OVERALL MASTER DEVELOPMENT PLAN OF WOODLAKE PARK

INFORMATION SHEET FOR
PRELIMINARY OVERALL AREA DEVELOPMENT PLAN
(P.O.A.D.P.)

FILE NO. 83-20-59-46
(To be assigned by the Planning Dept.)

Reference is made to the Preliminary Overall Area Development Plan (POADP) for the Woodlake Development Area (File #83-20-59-46) submitted for staff review and comment. Our analysis of the proposed Woodlake Unit-7E Subdivision within the Woodlake P.O.A.D.P. concludes that said proposal is in general compliance with the requirements set forth in Chapter 36 of the City Code. However, based on information given to us by your office, it is staff's understanding that the overall area shown on the P.O.A.D.P. is not being submitted for review at this time, since the remaining undeveloped area located to the east is to be developed by Doug Cross and a new P.O.A.D.P. for said area will be submitted for review upon completion. Further, that the new P.O.A.D.P. may be submitted under a different name and will show proposed Woodlake Parkway arterial extension and new development. Staff will formally review and comment on said plan at that time.

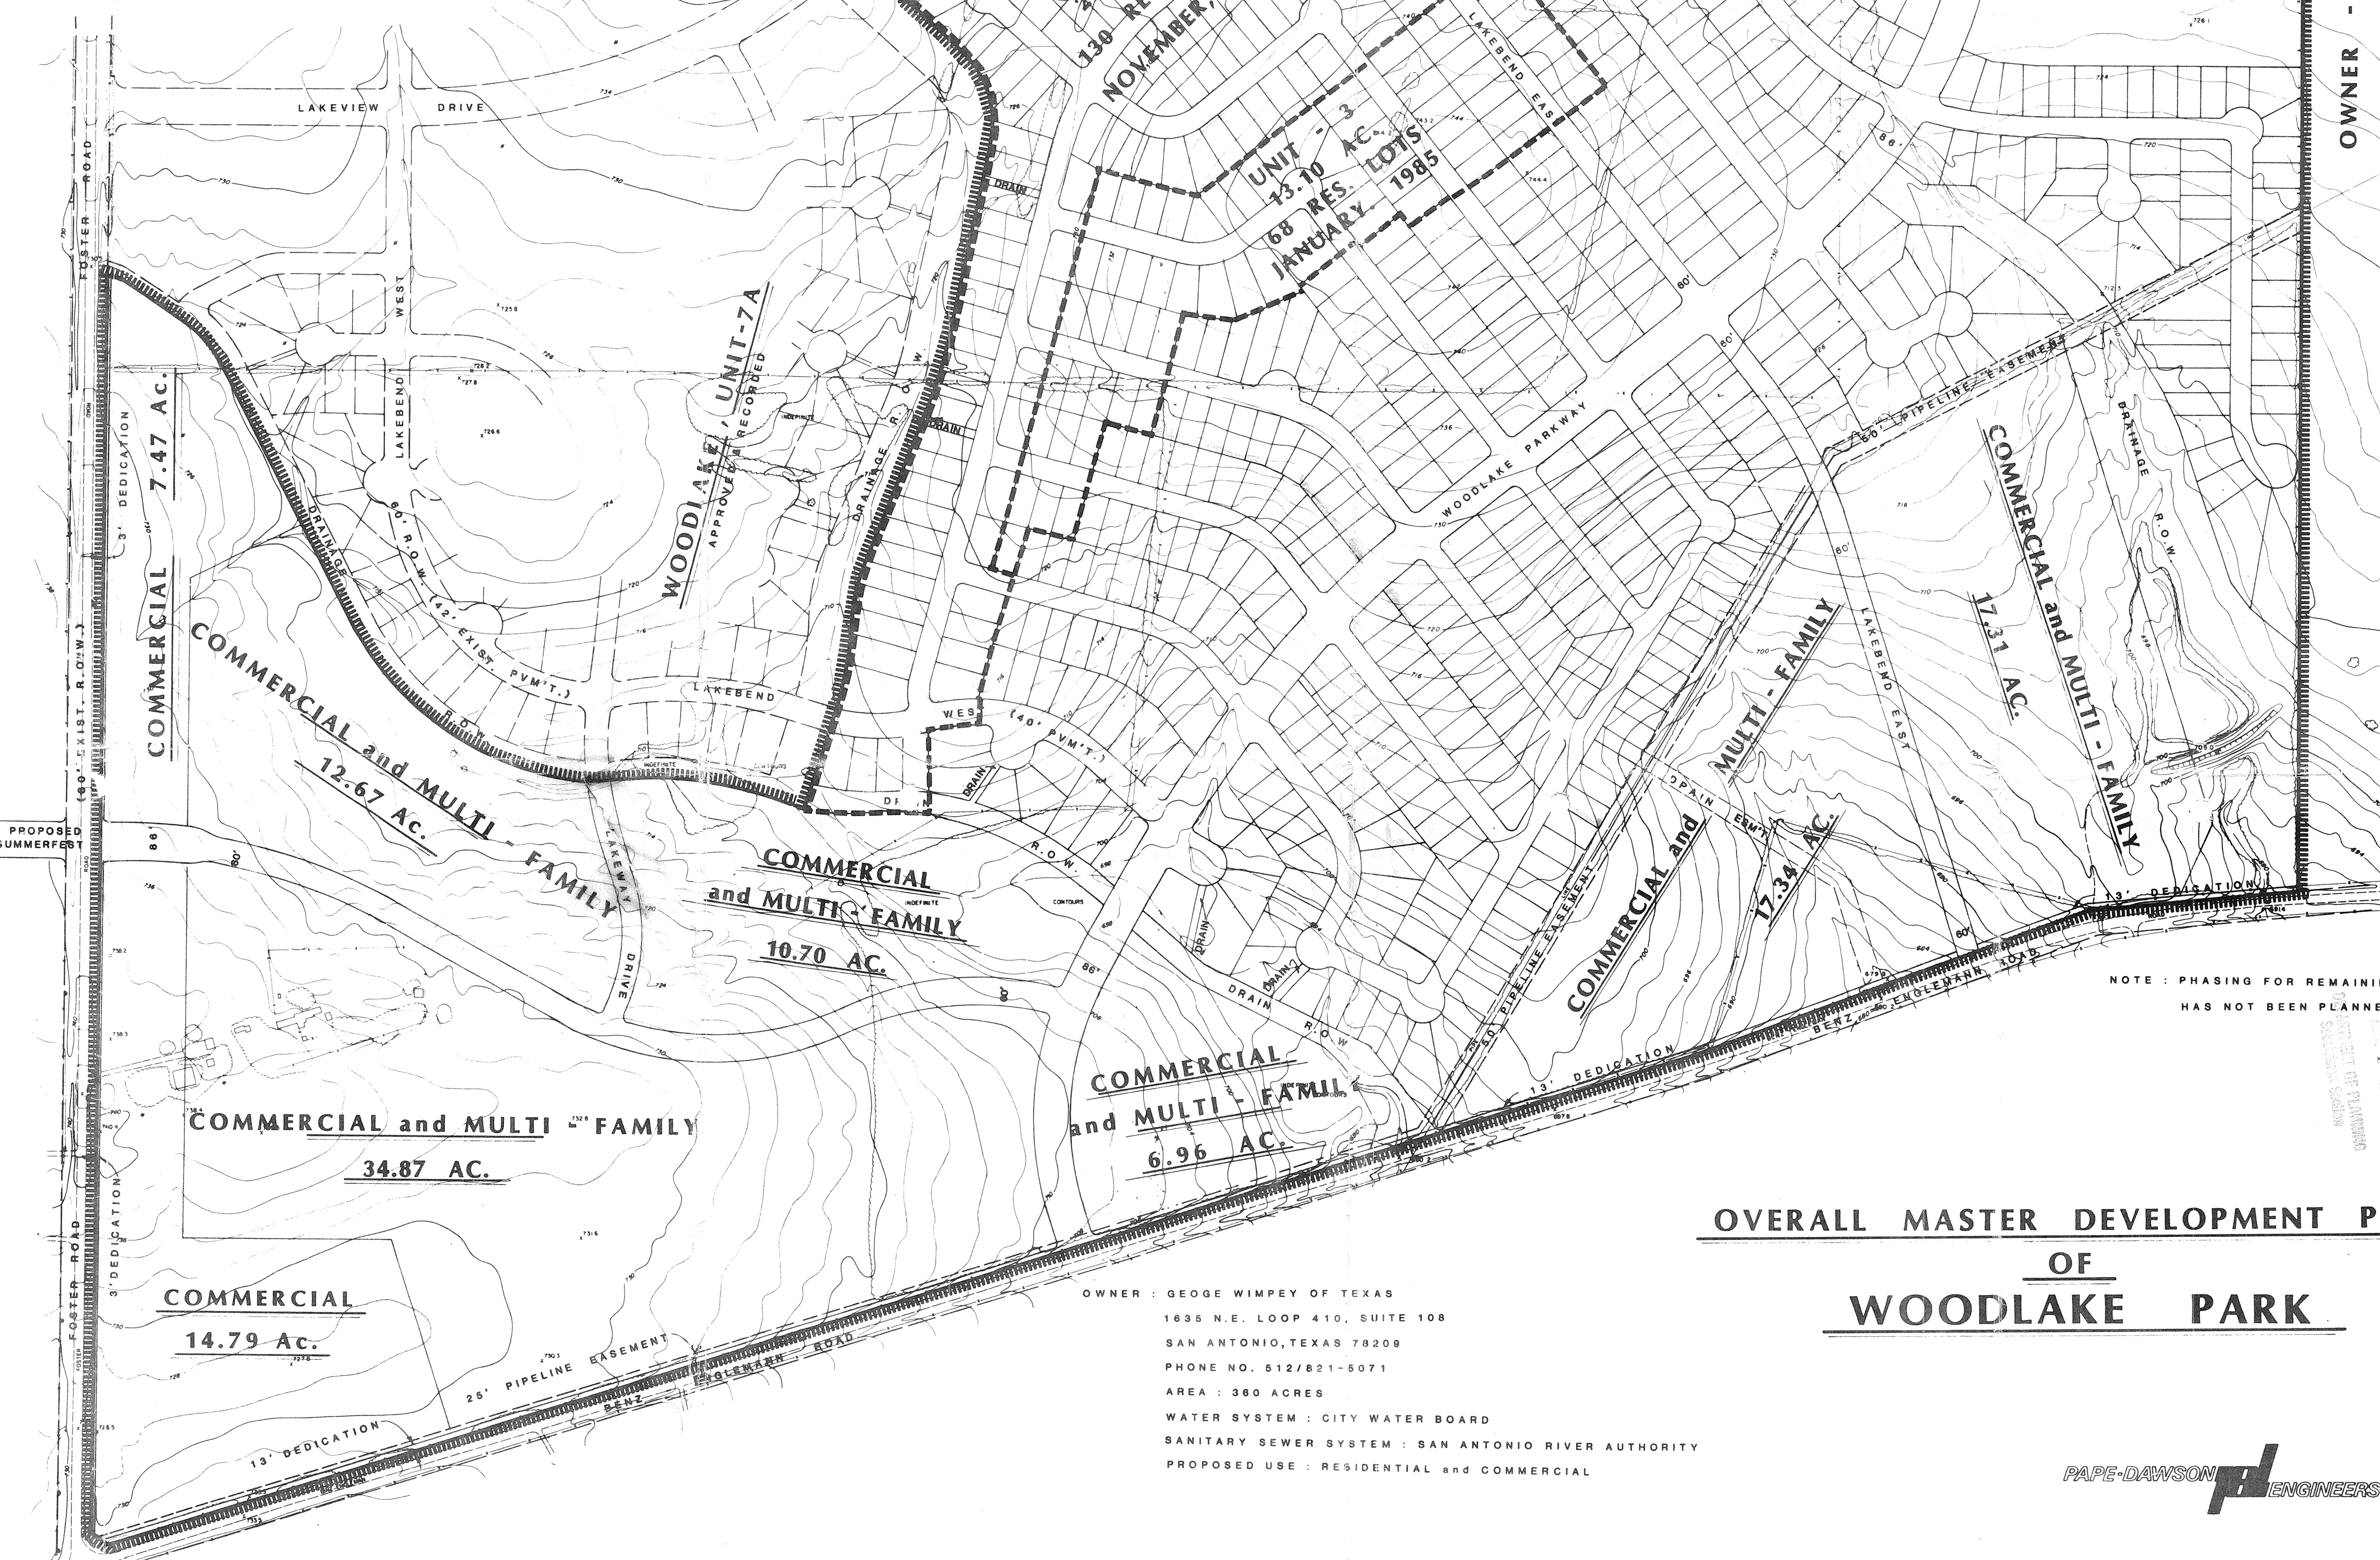
REMARKS Spoke to Reinhardt regarding the need for required info

(1) construction time tables & phasing (units)

(2) existing ROW width along 7th St

(3) proposed land use planned for each unit

(4) show any planned streets directly north of this proposal

(5) Explanation of street ded to county two streets
